Client:
Monograms Property Limited

Project:
Redevelopment of 8 Chapel Lane,
Spalding

Drawing Title:
Plan & Elevation as Proposed
PLANNING APPLICATION ISSUE
Date:
Jan. 2006
Scale:
1:50
Drawn by:
AJO
Checked by:
DAL
Drawing Number:
A0391-11
Rev:
A

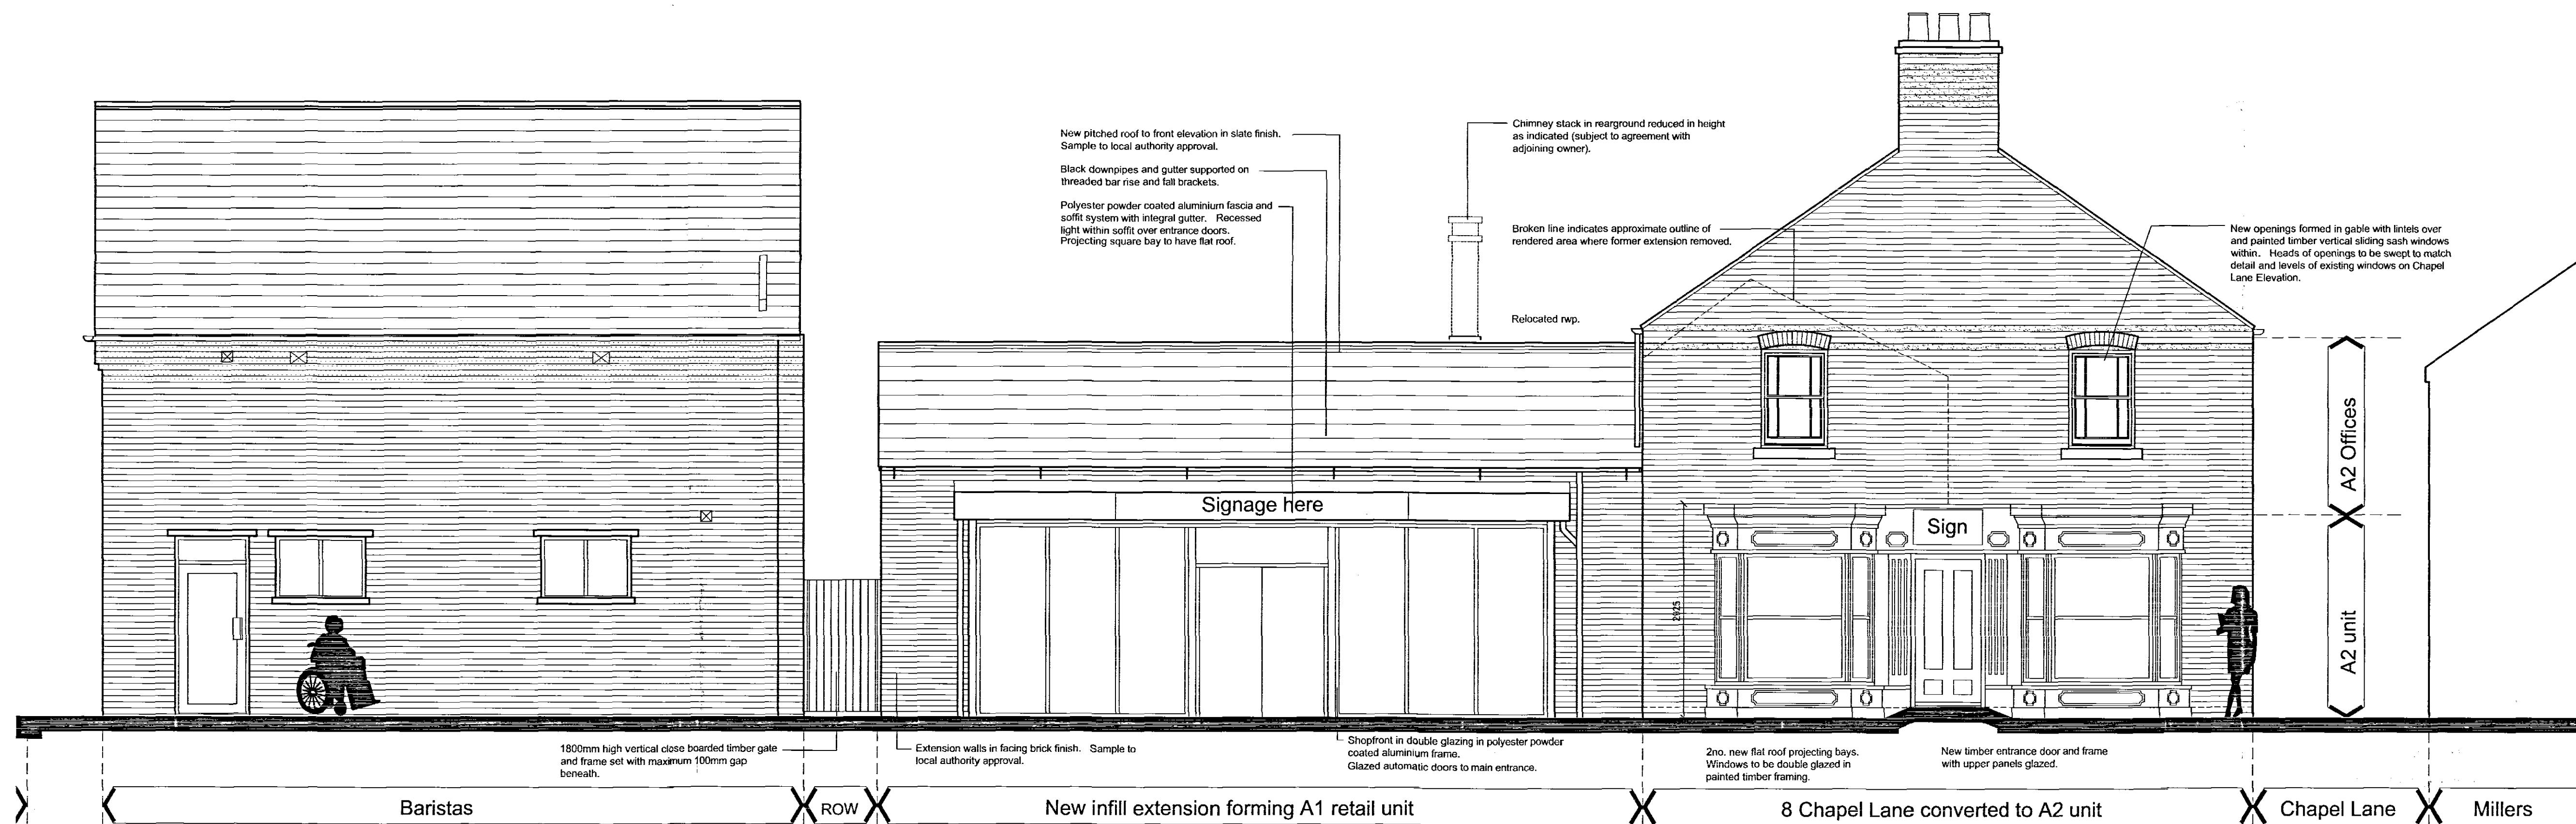
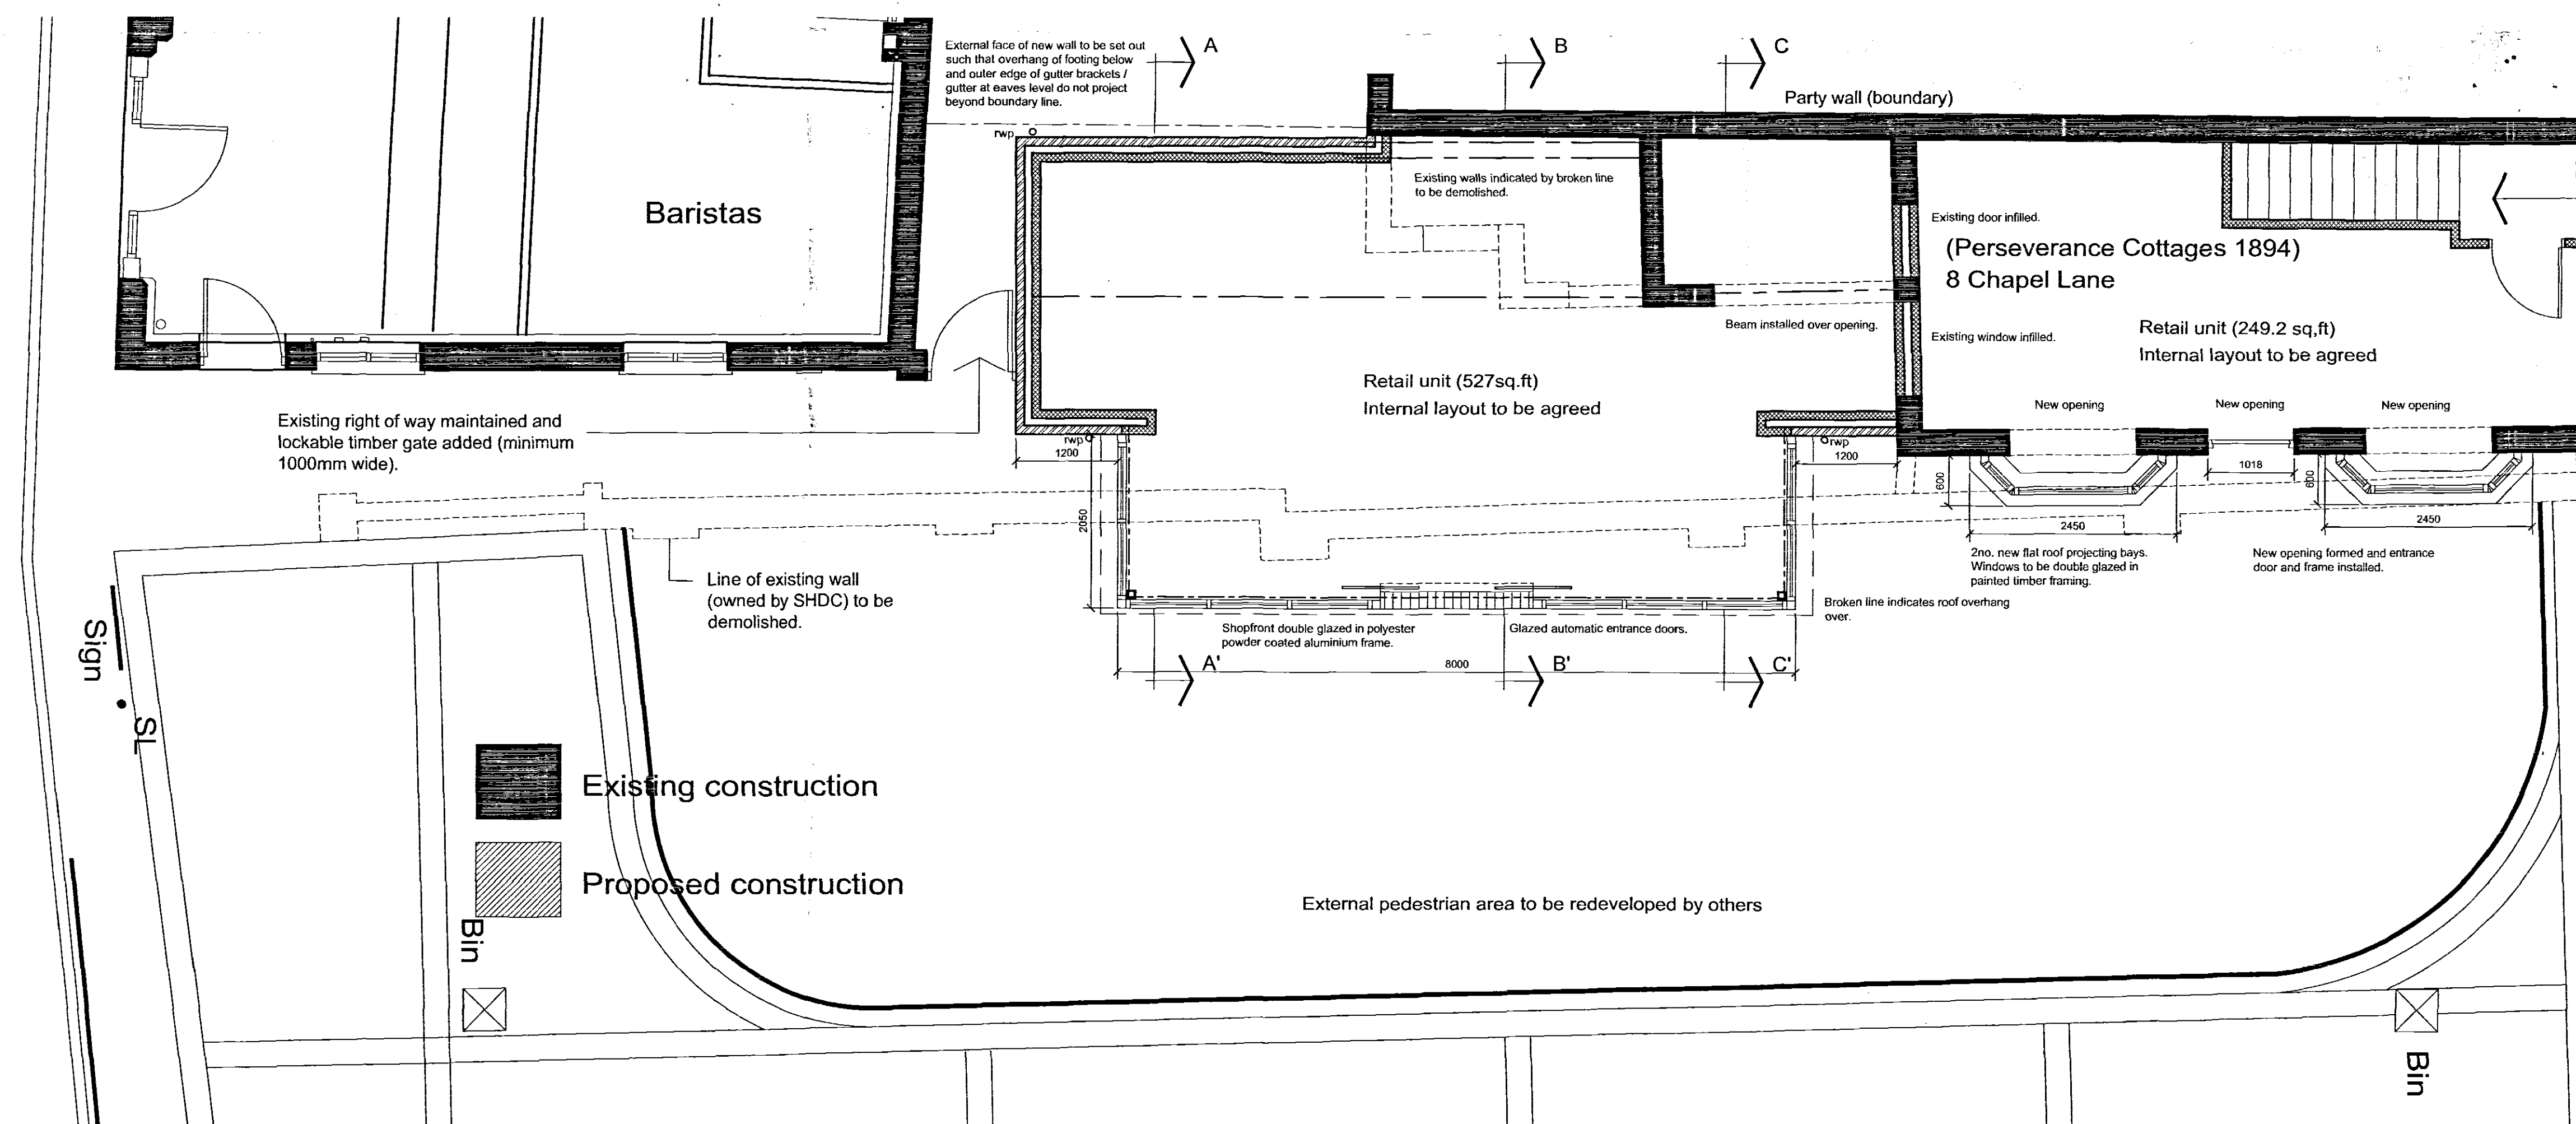
A	25/05/06	Amendments to SHDC planner's comments as follows: Front roof pitch on new unit made steeper. Leaves lowered. Storefront windows shifted in favour of brickwork. Rear wall moved forward to clear boundary. Landscape depth on new unit decreased and roof raised. Timber detailing around door in A2 unit revised. Bay window panel details revised. First floor windows in existing gable revised to swept head.	4/06
Ref	Date	Description	By
Revisions
